Item Name: Baggage Compartment Protector - Floor And Wall

DART SERVICE INSTRUCTION

TO AMEND INSTALLATION INSTRUCTIONS IIN-D407-781-2 REV. A OR LATER APPROVED REVISION
AND INSTRUCTIONS FOR CONTINUED AIRWORTHINESS ICA-D407-781 REV. 3 OR LATER REVISION

A	NEW ISSUE		13.04.08
REV.	DESCRIPTION	BY	DATE
DESIGN			
DRAWN			
CHECKED			
MFG. APPR.	N/A		
APPROVED			
DE APPR.			
DATE	13.04.08		
DART AEROSPACE LTD HAWKESBURY, ONTARIO, CANADA			
DRAWING NO. DSI 9649		REV. A SHEET 1 OF 2	
TITLE ALTERNATE INSTALL		SCALE NTS	
COPYRIGHT © 2013 BY DART AEROSPACE LTD. THIS DOCUMENT IS PRIVATE AND CONFIDENTIAL AND IS SUPPLIED ON THE EXPRESS CONDITION THAT IT IS NOT TO BE USED FOR ANY PURPOSE OR COPIED OR COMMUNICATED TO ANY OTHER PERSON WITHOUT WRITTEN PERMISSION FROM DART AEROSPACE LTD.

**FIGURE 1 - D3879-1 BAGGAGE COMPARTMENT WALL
PROTECTOR - ALTERNATE INSTALLATION**

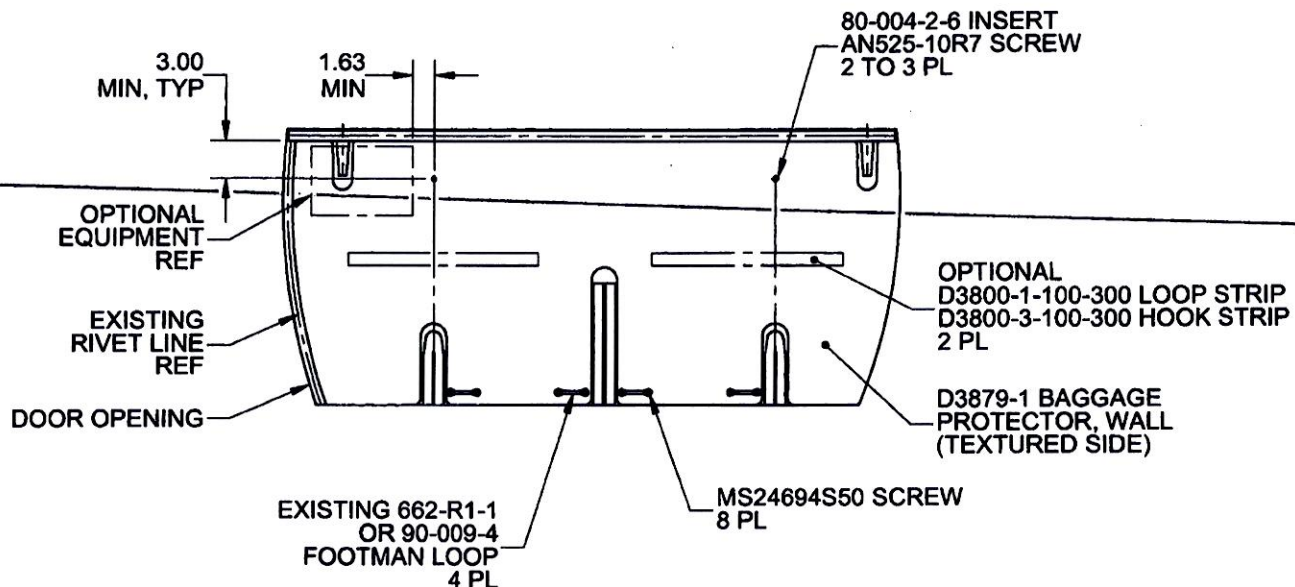
In some aircraft, the top portion of the D206-781-041 Baggage Compartment Wall Protector Kit cannot be installed as indicated in IIN-D407-781-2. The purpose of this DSI is to provide an alternate mounting method to fasten the top portion of the D206-781-041 Baggage Compartment Wall Protector Kit.

It is acceptable to replace qty(2) D3930-1 Clips with qty(2) 80-004-2-6 Inserts. Locate and mark location of the two attachment holes on the baggage compartment wall as shown in Figure 1 of this service instruction. Install 80-004-2-6 Inserts at the marked locations in accordance with Section 3-2-12 of BHT-206-SRM-1. It is acceptable to trim the wall protectors to accommodate optional equipment or transfer attachment holes to the wall protector and install the optional equipment on top of the wall protector with longer fasteners.

Amend the D206-781-041 Baggage Compartment Wall Protector Kit parts list as follows:

Qty -061	Qty -031	Qty -041	Part Number	Description
X			D206-781-061	BAGGAGE COMPARTMENT PROTECTOR KIT (FLOOR AND WALL)
1	X		D206-781-031	BAGGAGE COMPARTMENT FLOOR PROTECTOR KIT
1		X	D206-781-041	BAGGAGE COMPARTMENT WALL PROTECTOR KIT
		2	AN525-10R7	SCREW
		2	80-004-2-6	INSERT
